Appendix K

Transportation Assessment

1111 South Hill Street
DOT Case No. CEN20-47816

Subject: **TRANSPORTATION ANALYSIS FOR THE PROPOSED MIXED-USE PROJECT LOCATED AT 1111 SOUTH HILL STREET (ENV-2019-4121-ND/CPC-2018-6005-CA)**

Figure 2
 Site Plan: Residential Option
 1111 S. Hill Street

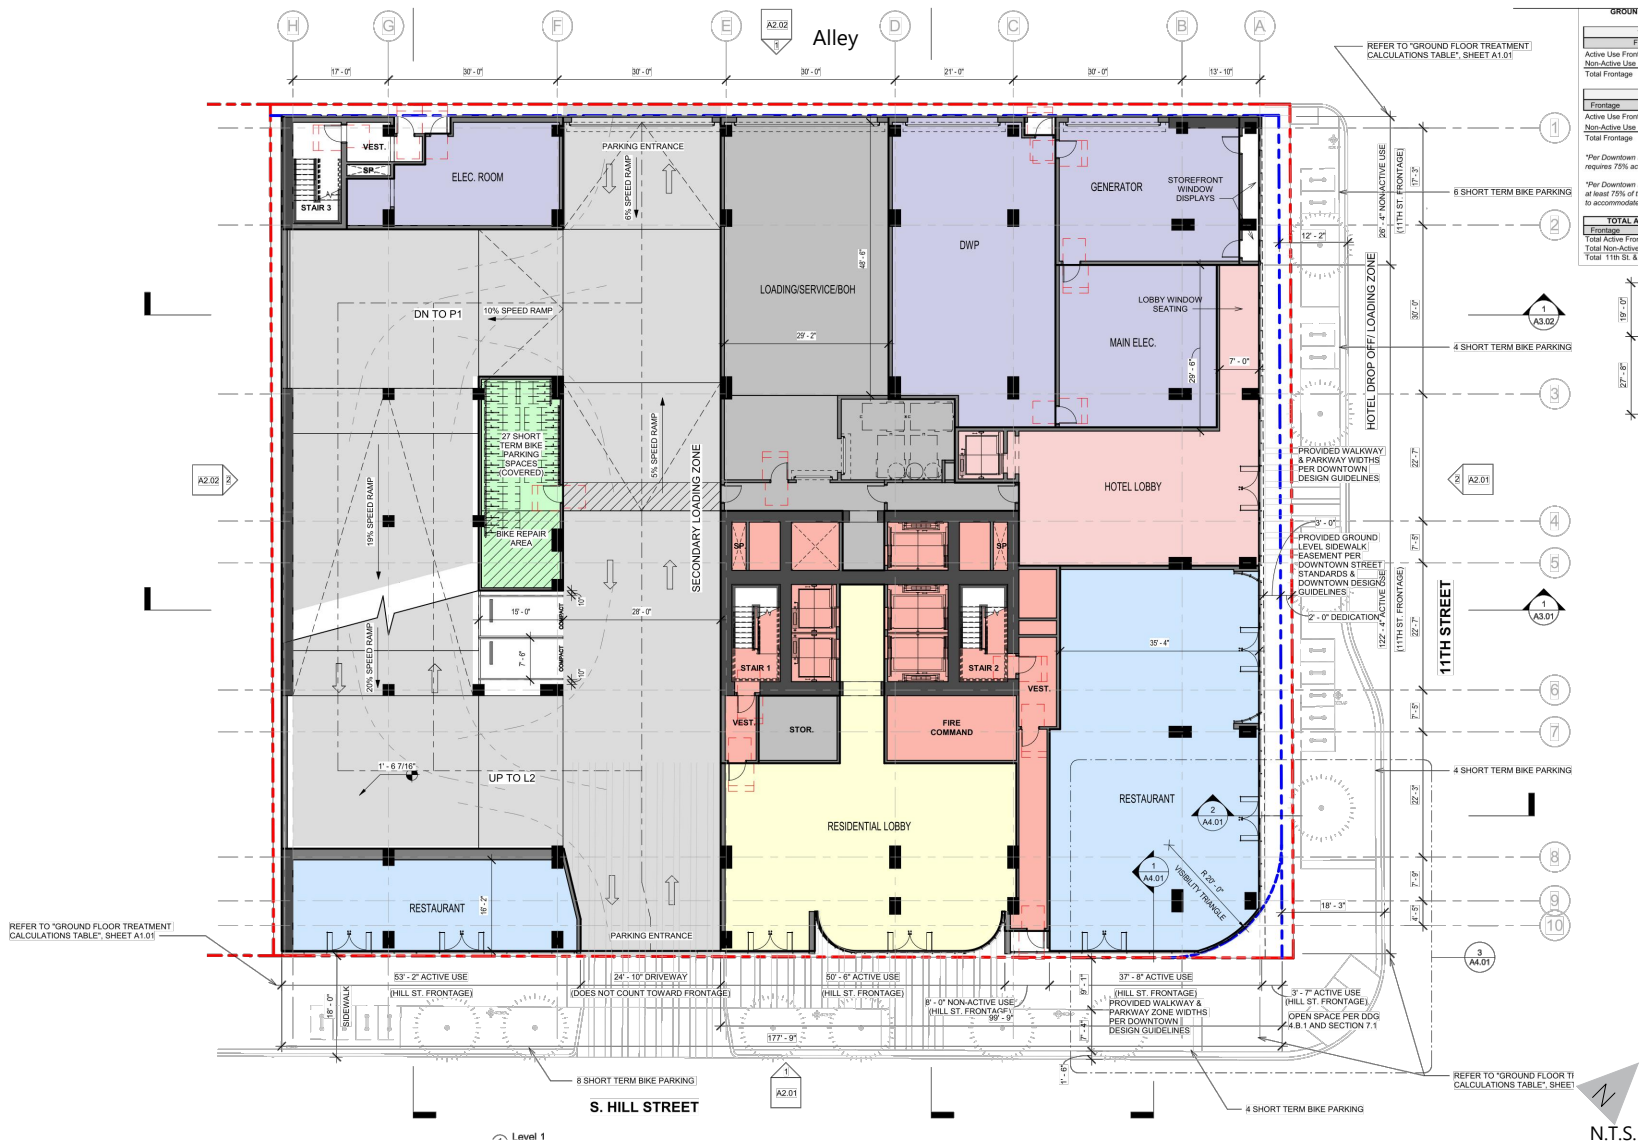
The conceptual site plan (see **Attachment C**) is acceptable to DOT. Vehicular access to the site will be provided via one driveway located on South Hill Street and one driveway located on the adjacent alley to the project site. Pedestrian access to the hotel portion of the site will be located on 11th Street, pedestrian access to the residential portion of the site will be located on Hill Street, and pedestrian access to the restaurant spaces will be located on both Hill Street and 11th Street. However, the review of this study does not constitute approval of the dimensions for any new proposed driveway. This requires separate review and approval and should be coordinated with DOT's Citywide Planning Coordination Section (201 N. Figueroa Street, 5th Floor, Room 550, at 213-482-7024). In order to minimize and prevent last minute building design changes, the applicant should contact DOT for driveway width and internal circulation requirements prior to the commencement of building or parking layout design.
